Subject: Response to NRC First Request for Additional Information on License
Amendment Request No. 9 to Holtec International HI-STORM 100 Certificate of
Compliance No. 1014

Holtec Response to First Request for Additional Information on License Amendment Request 1014-9

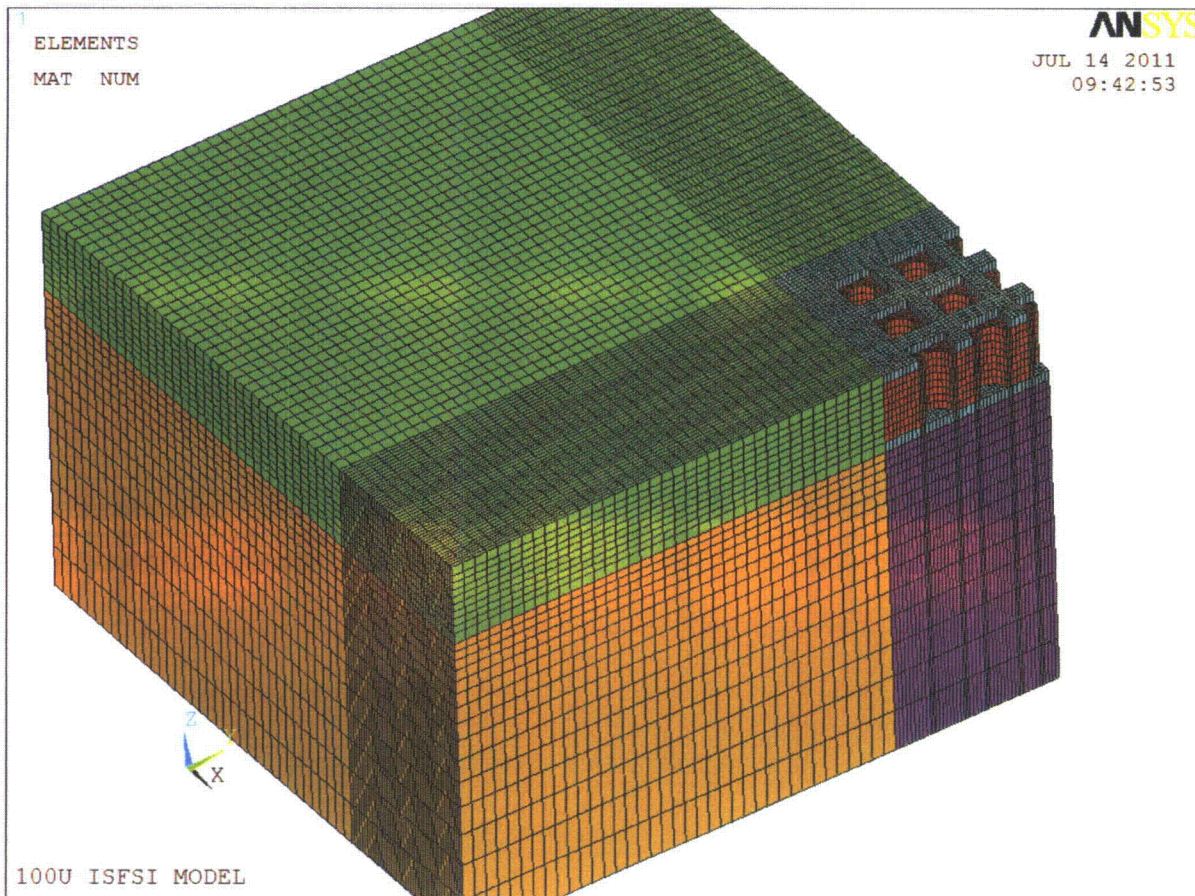
- 3-2 Provide an analysis for long-term differential settlement using an appropriate finite element model.

Using the methodology discussed in the Final Safety Analysis Report (FSAR) Section 2.1.2.i to capture the effect of long-term settlement under the action of applied loads, the elastic modulus of the soil in Space C, which is located directly beneath the Support Foundation Pad (SFP) in the finite element model shown in Figure 3.1.14, is reduced. Only the soil directly beneath the SFP is included in the model. All of the soil beyond the edges of the SFP is not included in the model. Such a model cannot capture the flexural effects

Holtec Response: In order to capture the long-term differential settlement effects on the pads more accurately, the existing structural analysis model has been extended in both lateral directions, thereby including the soil in Space B and Space D (see FSAR Figure 2.1.5). The lateral extent of the structural analysis model is sufficiently large (111 ft from the edge of the SFP and TSP) to capture the flexural moments due to long-term differential settlement. The figure below shows the extended finite element (FE) model.

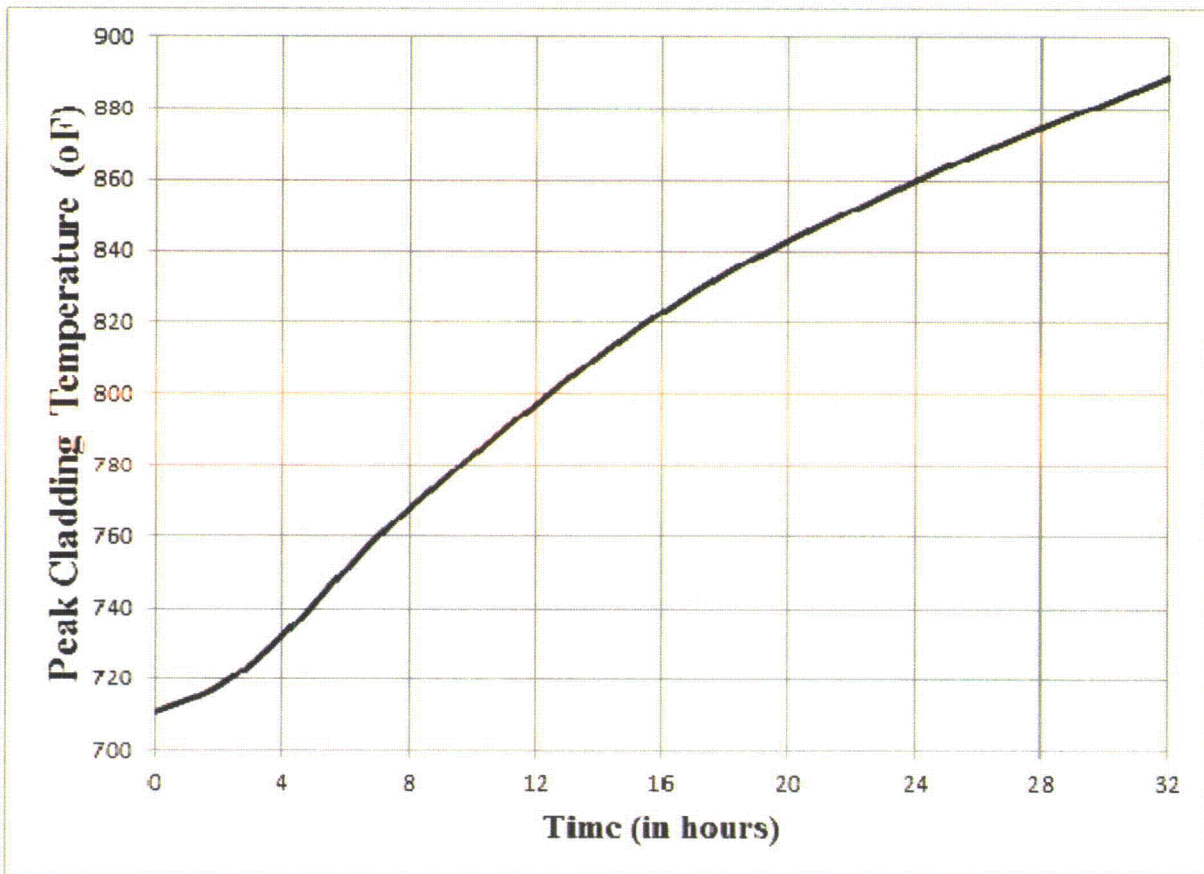
4-4 (1) Explain why the 32-hour time period is selected for 100% blocked inlet analysis specified on Table 4.6.5, and (2) add the periodic surveillance program in TS for guidance to perform cask operations.

The applicant evaluated the effect of an event of 100% blockage of air inlets in HI-STORM 100 FSAR 4.6.2.4 (Rev. 9A) for the accident events. The 32-hour blocked inlet ducts maximum temperatures are shown in Table 4.6.5 of the FSAR. However, it is not clear to the staff why the 32-hour time period was selected to evaluate the temperatures of the components. The applicant should explain the selection of this time limit (24 hours) used in the accident analysis.

Figure 3.I.14-B; Finite Element Model of the ISFSI Reinforced Concrete Structures for
Simulation Model IV

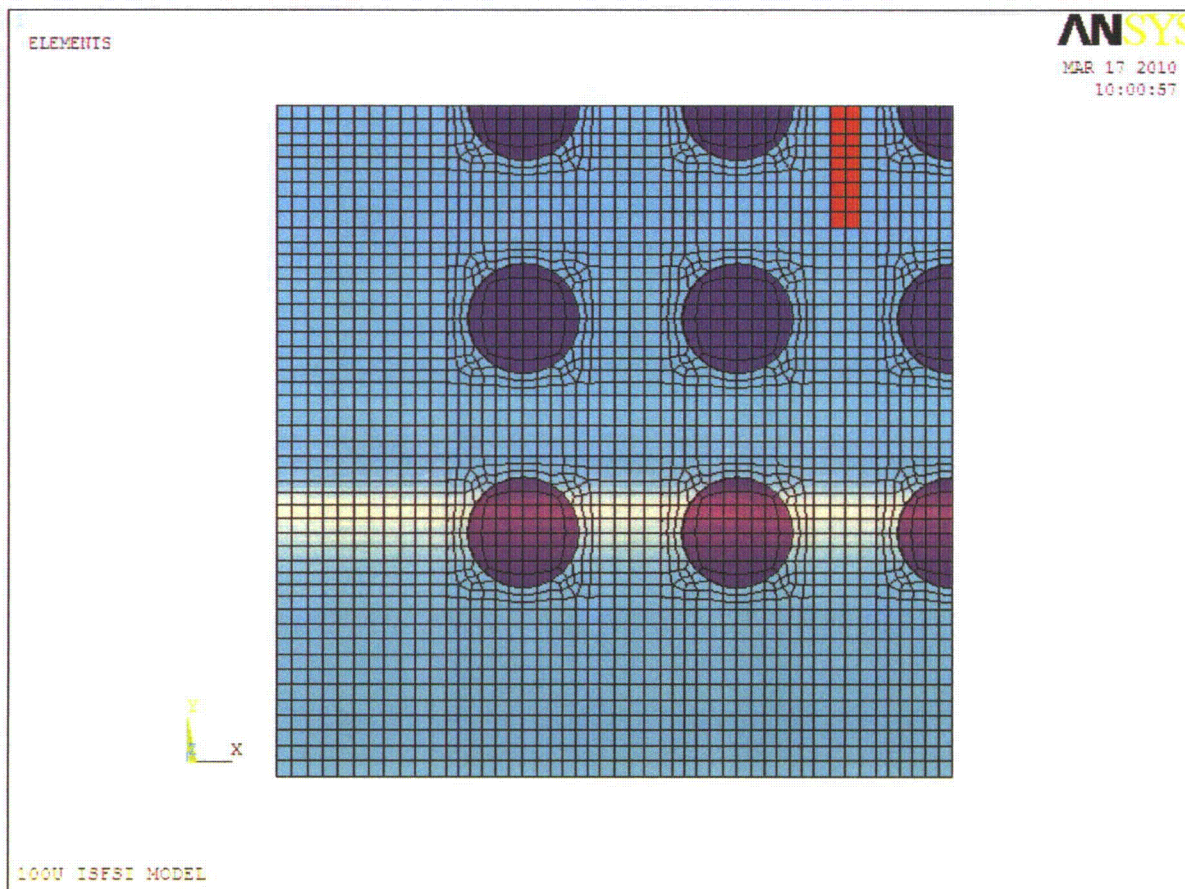
made as a result of this RAI response are limited to subsection 3.1.4.7.3, Tables 3.1.6 through 3.1.13, with the exception of 3.1.9 and 3.1.11, and Figure 3.1.14-B. Minor editorial changes we done to figure titles to align them with the current text.

which is shown in Figure 3.I.14-B. In this model, the lateral subgrade surrounding the retaining walls is completely removed to bound any future excavation activities associated with the construction of a new underground ISFSI, and for consistency with the LS-DYNA SSI simulation model (see Figure 3.I.3-C). For Simulation Model IV, the middle row of VVM locations is loaded similar to Simulation Model II (see Figure 3.I.22).
